OFFICE OF THE ATTORNEY GENERAL  
STATE OF ILLINOIS

RE: Accessibility Complaint #2013-DRC-4805  
William Hatch Elementary School  
1000 N. Ridgeland Avenue  
Oak Park, Illinois 60302

**William Hatch Elementary School  
1000 N. Ridgeland  
Oak Park, IL 60302  
2013-DRC-4805**

**Attachment A**

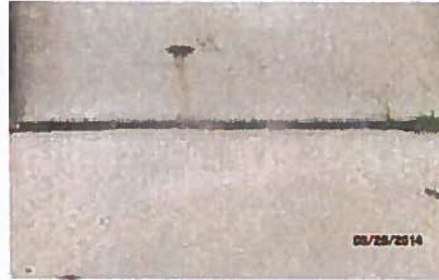
7. Accessible routes shall not have running slopes greater than 1:20 [running slope = 5.3%]. IAC § 400.310(a)(6); Standards § 402.2.

8. Nowhere shall the cross slope of an accessible route exceed 1:50 [cross slope of the route leading to the ramp = 5.3%]. IAC § 400.310(a)(6).
